2 SUB2012-00037

JOE MASON SUBDIVISION

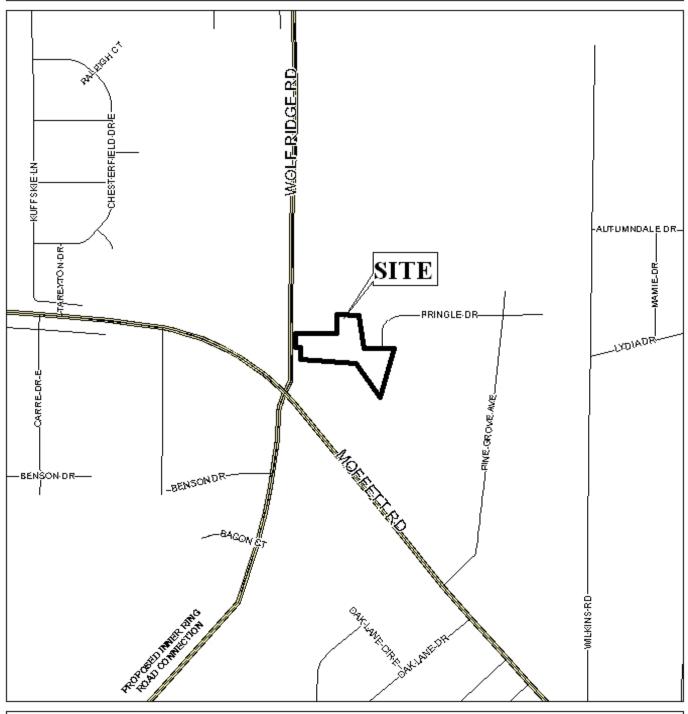
The proposed lot is not labeled on the preliminary plat, and should be labeled as "Lot 1" or "Lot A".

The lot size is not labeled in square feet or acres on the preliminary plat; however, the lot exceeds the minimum lot size requirement as required by Section V.D.2. of the Subdivision Regulations. The lot size should be labeled in square feet and acres on the Final Plat, if approved.

The site fronts onto Wolf Ridge Road, a planned major street as depicted in the major street plan component of the City of Mobile Comprehensive Plan. The major street plan stipulates a 100-foot right-of-way for Wolf Ridge Road in the area; a 50-foot right-of-way is depicted on the plat. If approved, dedication to provide 50 feet from the centerline of Wolf Ridge Road would be required. It should also be noted that while not illustrated on the preliminary plat, a portion of the lot does have frontage along Pringle Drive. The portion which contains the frontage along Pringle Drive was the subject of an approved subdivision at the Planning Commission's May 6, 2004 meeting. A condition of approval at that time required a note on the Final Plat stating that the lot be denied direct access to Pringle Drive. If approved, the Final Plat should be revised to illustrate the frontage along Pringle Drive as well as a note stating that the lot is denied direct access to Pringle Drive.

The 25-foot minimum building setback line, required in Section V.D.9., is not illustrated and labeled on the preliminary plat. If approved, the 25-foot building setback line should be illustrated and labeled on the Final Plat from the new property line after dedications along all street frontages.

It should be noted that the proposed lot does not meet the standards for width-to-depth ratio. Section V.D.3. of the Subdivision Regulations states that lot depth should not exceed 3.5 times the width of the lot at the building setback. As proposed, Lot 1 will be 137.45'± wide at the setback line and 491.45'± deep, resulting in a lot that is approximately 10.37'± deeper than would normally be allowed. However, the previous approval of the lot by the Planning Commission would make a waiver of Section V.D.3. of the Subdivision Regulations appropriate.

As a means of access management, a note should be placed on the Final Plat, if approved, stating that Lot 1 is limited to one curb cut to Wolf Ridge Road, with the size, location and design to be approved by Traffic Engineering and conform to AASHTO standards.

It should be noted that upon reviewing City of Mobile 2010 aerial photos of the site, there appear to be several existing structures. If approved, the applicant should apply for a planned unit development to have multiple buildings on a single building site, or obtain demolition permits so there is only one structure remaining.

Based upon the preceding, the application is recommended for tentative approval, with a waiver of Section V.D.3. of the Subdivision Regulations, subject to the following conditions:

- 1) label the subject lot as "Lot 1" or "Lot A";
- 2) label of the lot size in square feet and acres;
- 3) dedication to provide 50' from the centerline of Wolf Ridge Road to the City of Mobile;

- 4) successful application for a planned unit development or obtain demolition permits so that only one structure remains on the site before the signing of the Final Plat;

- 5) placement of the 25-foot minimum building setback line along all right-of-way frontages;
- 6) compliance with Engineering comments (Need to dedicate additional ROW to provide 50' from centerline of Wolf Ridge Road. Sidewalk is required to be constructed along the frontage of the property, unless a sidewalk variance is approved. Any work performed in the existing ROW (right-of-way) such as driveways, sidewalks, utility connections, drainage, irrigation, or landscaping will require a ROW permit from the City of Mobile Engineering Department (208-6070) and must comply with the City of Mobile ROW (Mobile City Code, Chapter 57, Article VIII).);

- 9) placement of a note on the Final Plat limiting Lot 1 to one curb cut to Wolf Ridge Road, with the size, design, and location to be approved by Traffic Engineering and conform to AASHTO standards;

- 10) illustration of frontage along Pringle Drive on the Final Plat;
- 11) placement of a note on the Final Plat stating the lot is denied direct access to Pringle Drive; and
